Access Compliance Report

Public Rights-of-Way

Intersection ID: 23312	Main Street: BALTUSROL_LN	Cross Street: GLENEAGLES_RD	Location: SE
ADA ID: 076279B1A6F3	Ramp Type: PerpDiag	Initial Pass/Fail: Fail	Overall Compliance: No
Severity Score: 21.25			
Codes/Mitigation Info/Possible Solution		Field Measurements/Component Compliance

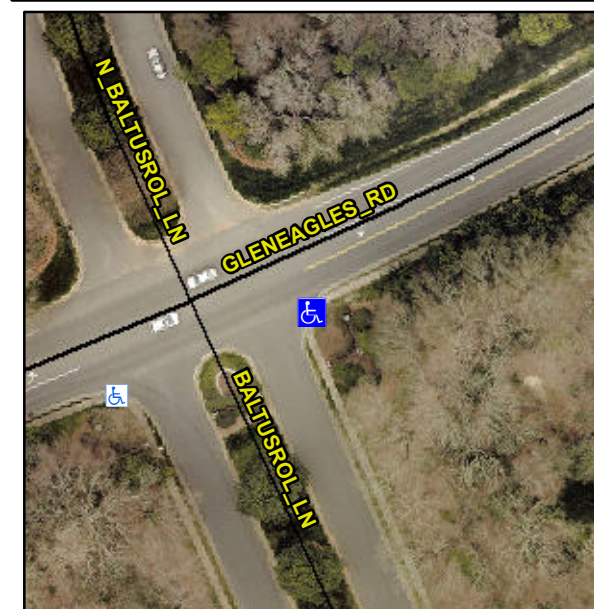
Not Found, R304.5.1, R304.2.2

Compliance	Description	Data	Compliance	Description	Data
N/A	Ramp Length (in)	48.0	No	Ramp Slope (%)	8.7
No	Ramp Width (in)	47.0	Yes	Ramp XSlope (%)	0.3
N/A	Flare Type LT	N/A	N/A	Flare Type RT	N/A
N/A	Flare Slope LT (%)	N/A	N/A	Flare Slope RT (%)	N/A
N/A	Flare Traversable LT?	N/A	N/A	Flare Traversable RT?	N/A
N/A	Landing Length (in)	N/A	N/A	DWS Provided?	N/A
N/A	Landing Width (in)	N/A	N/A	DWS Contrast?	N/A
N/A	Landing Slope (%)	N/A	N/A	DWS Length (in)	N/A
N/A	Landing X Slope (%)	N/A	N/A	DWS Full Width?	N/A
N/A	Landing Curb? (Y/N)	N/A	N/A	DWS Offset (in)	N/A
N/A	Shared Landing?	N/A			
N/A	Gutter Ponding?	N/A	N/A	Gutter Slope (%)	N/A
N/A	Gutter Lip Ht (in)	N/A	N/A	Gutter X Slope (%)	N/A
N/A	Painted X Walk1?	No	N/A	Painted X Walk2?	No
	X Walk 1 Direction	To N		X Walk 2 Direction	To W
N/A	X Walk 1 Width (in)	N/A	N/A	X Walk 2 Width (in)	N/A
	X Walk 1 Slope (%)	6.9		X Walk 2 Slope (%)	1.1
	X Walk 1 X Slope (%)	3.5		X Walk 2 X Slope (%)	3.2

Remove & Replace Curb Ramp With Two New Directional Ramps or Equivalent.
